**MACEDONIA PLANNING COMMISSION
MEETING AGENDA
MARCH 21, 2022**

**MACEDONIA PLANNING COMMISSION
FEBRUARY 14, 2022
MEETING MINUTES**

Re: Plan Review Comments: Dominion – 9796 Shepard Rd., Station Replacement

PROPOSED
SITE PLAN

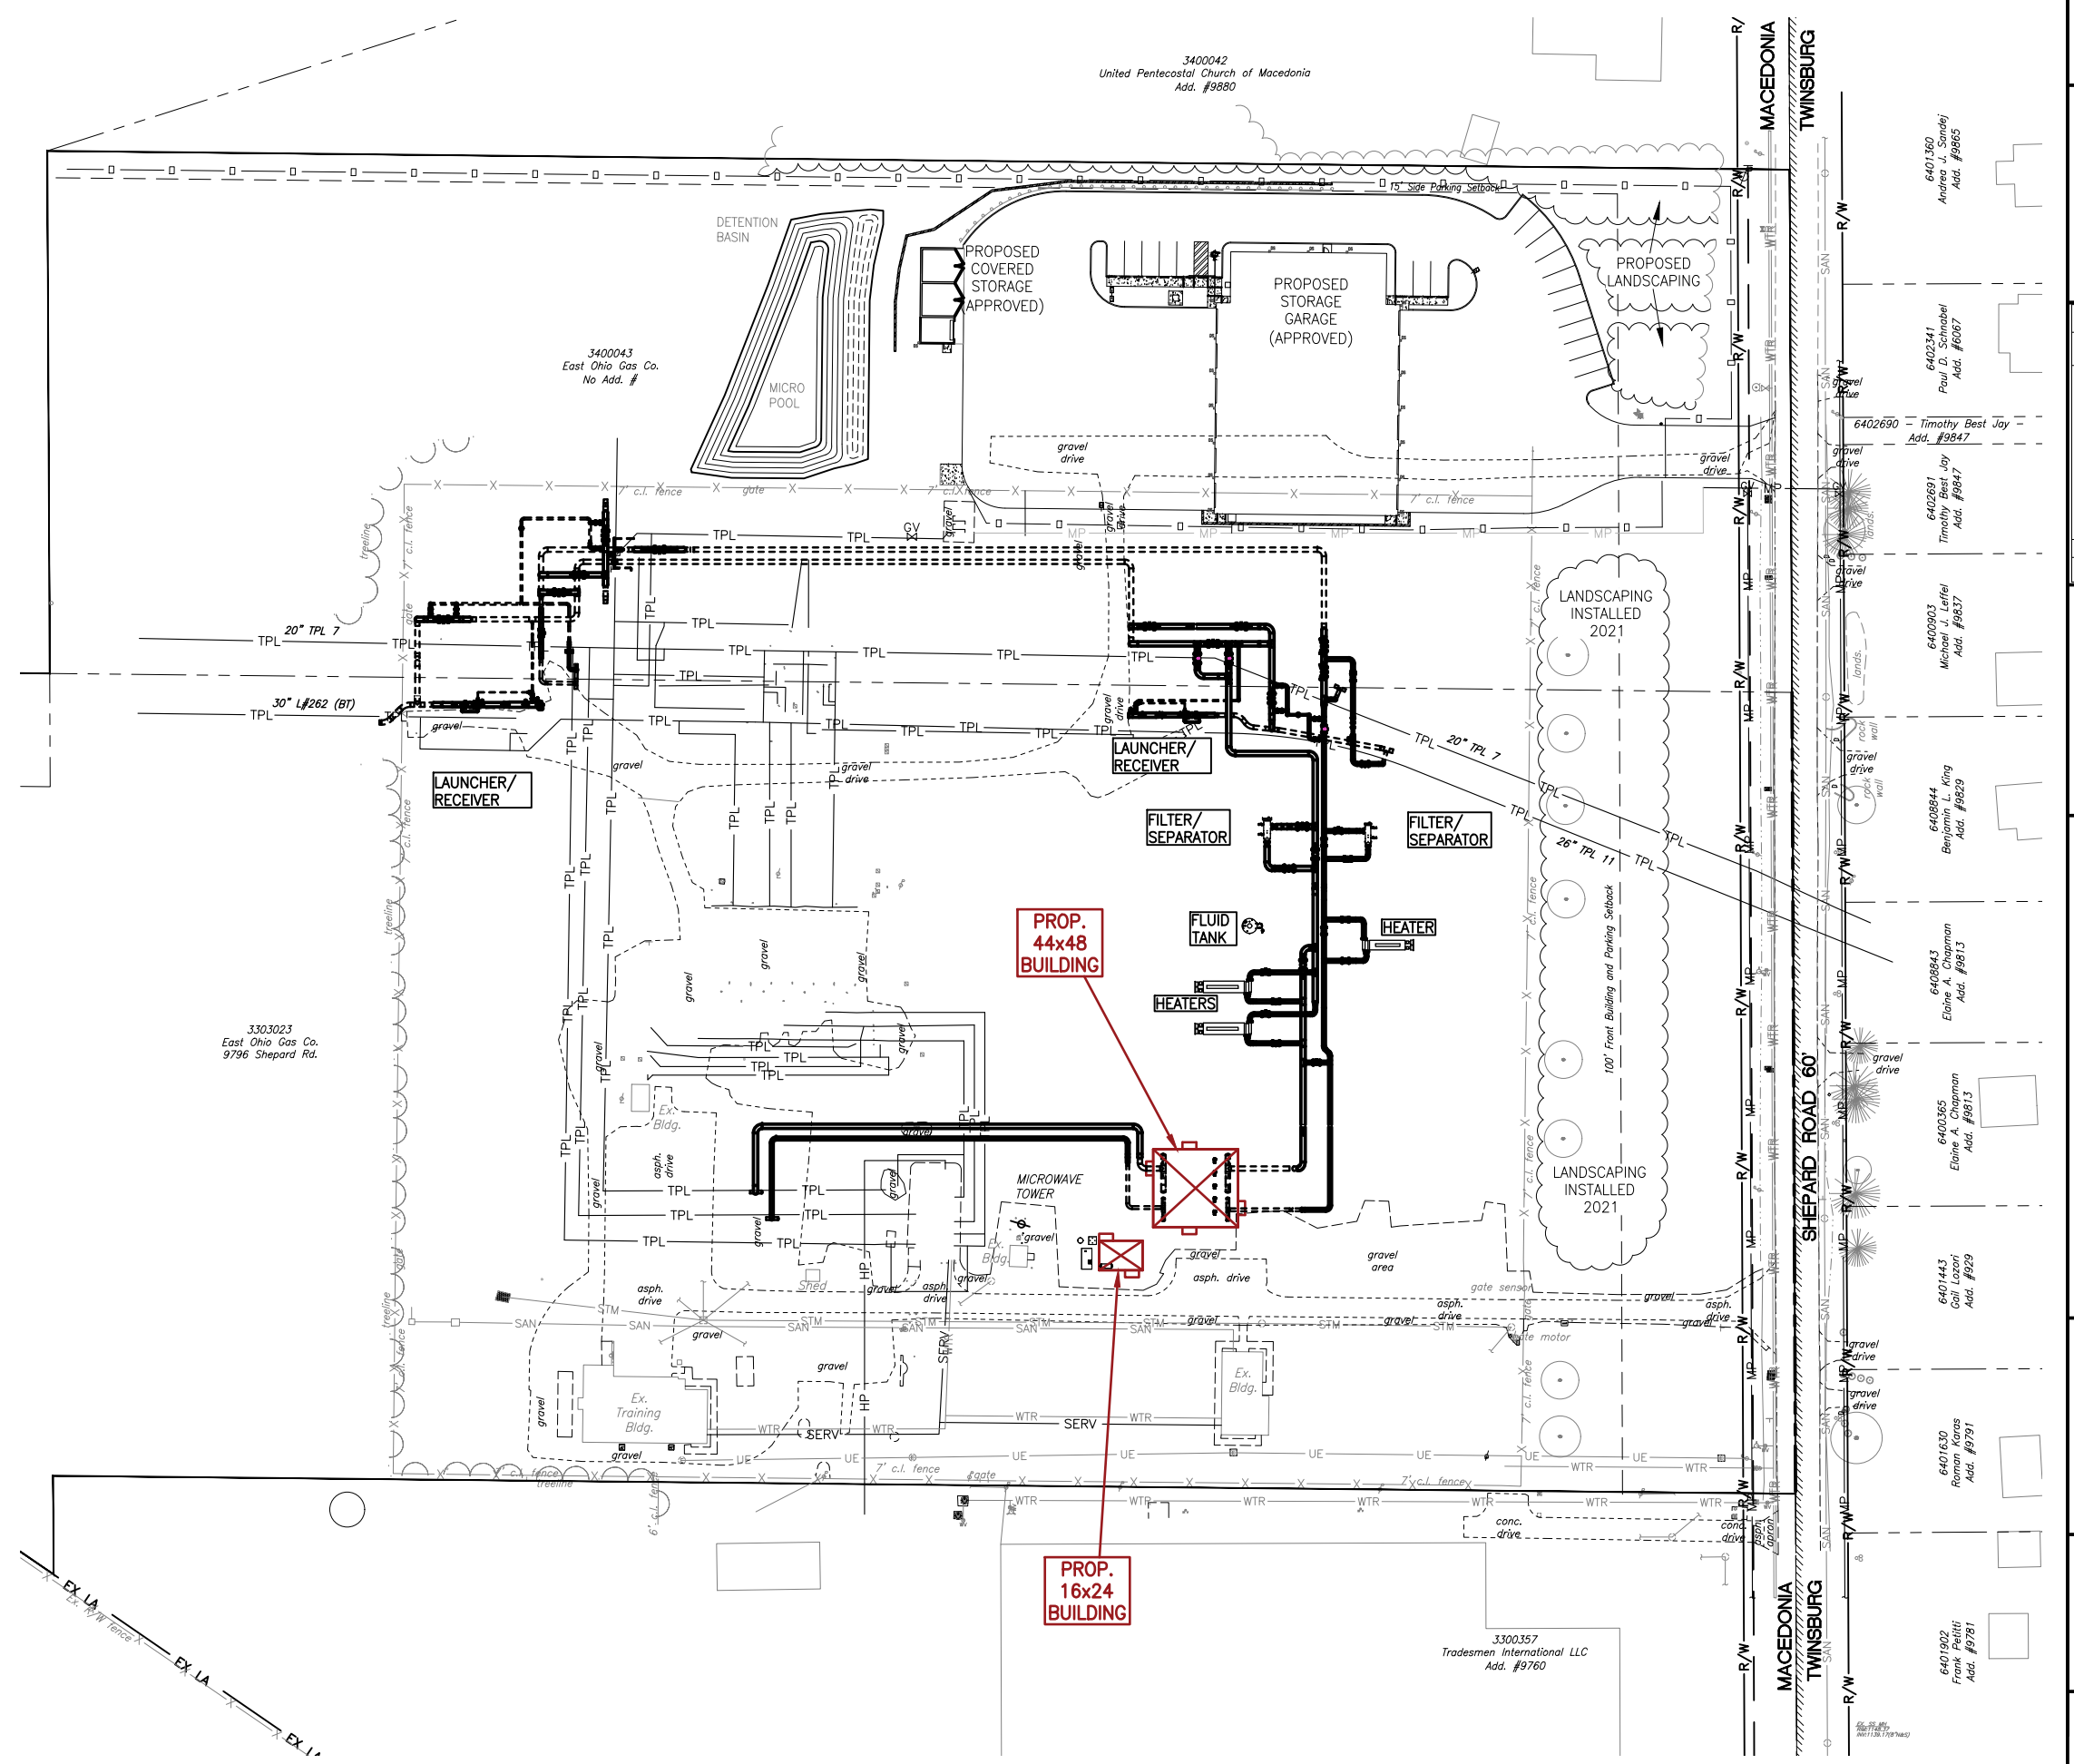
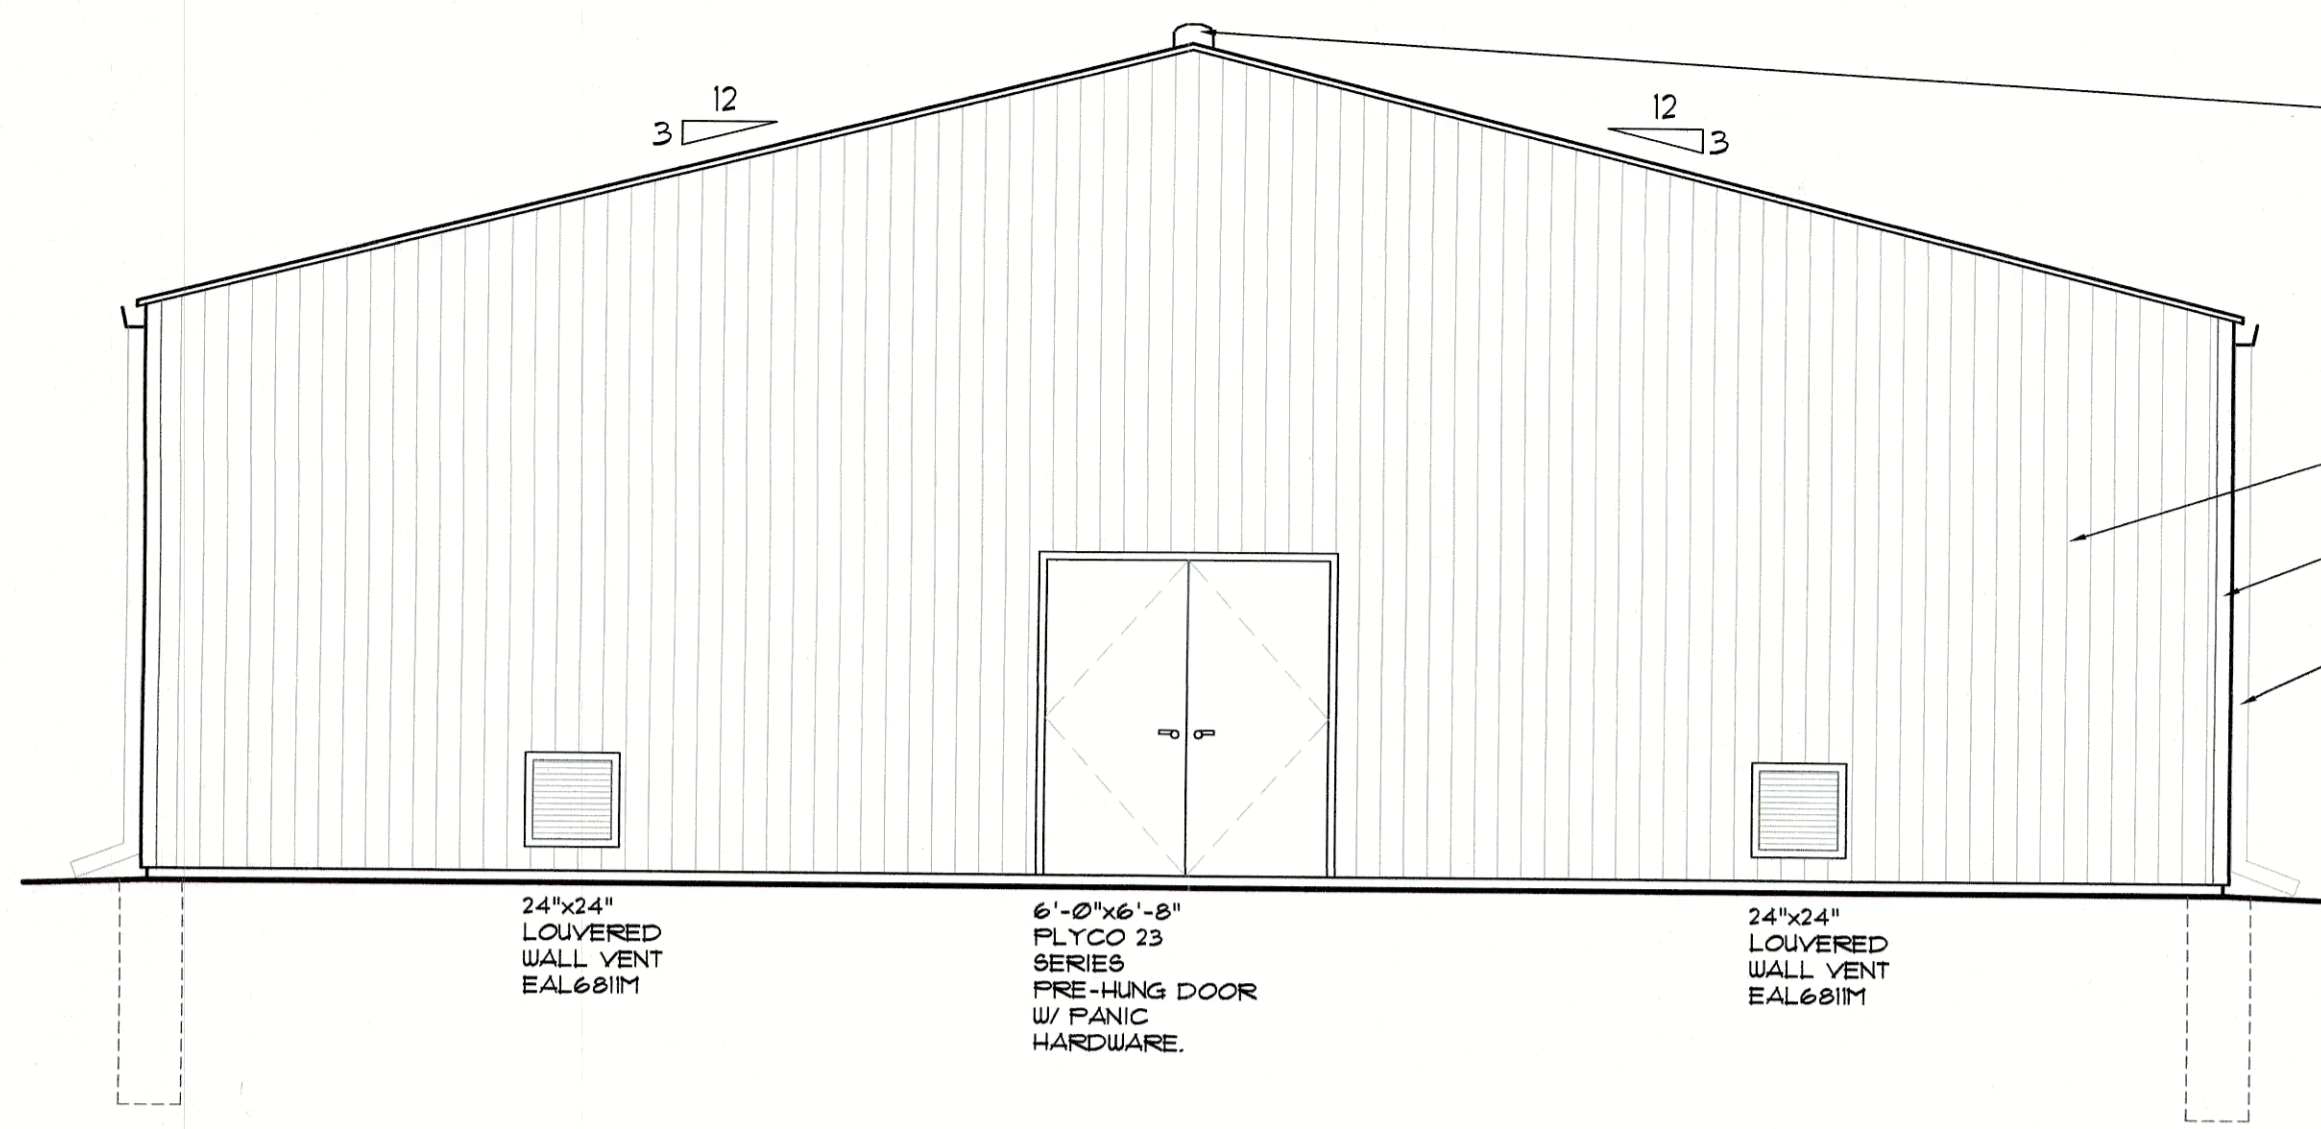
1. Previously submitted plans for the Station Replacement show a large proposed gravel driveway/parking area for the “station replacement” site. Storm water management, with regards to both quality and quantity, needs to be provided, in conformance with Chapter 920 of Macedonia Codified Ordinances, as only storm water management for the proposed “Vehicle Storage Garage” is currently shown on the plans. No storm water management is shown for the “Station Replacement” site, this is required as the amount of grass is being reduced and replaced with hard surface or gravel. This project will increase storm water runoff, thus management is required. This comment was not addressed from the previous Planning Commission submittal and meeting of Sept., 2021.

The site plans submitted are for the proposed 44' x 48' building and a proposed 16' x 24' building. Two site plans were included and show different locations for what is being proposed. Two buildings on the North side of the site and two buildings on the South side, adjacent to the existing brick buildings are shown. One site plan indicates the buildings located on the North side of the site have been approved. The following comments/recommendations refer to the proposed 44' x 48' and 16' x 24' building plans and not their placement on the site.

6. The site plan show a "microwave tower". Please verify this has been reviewed/addressed.
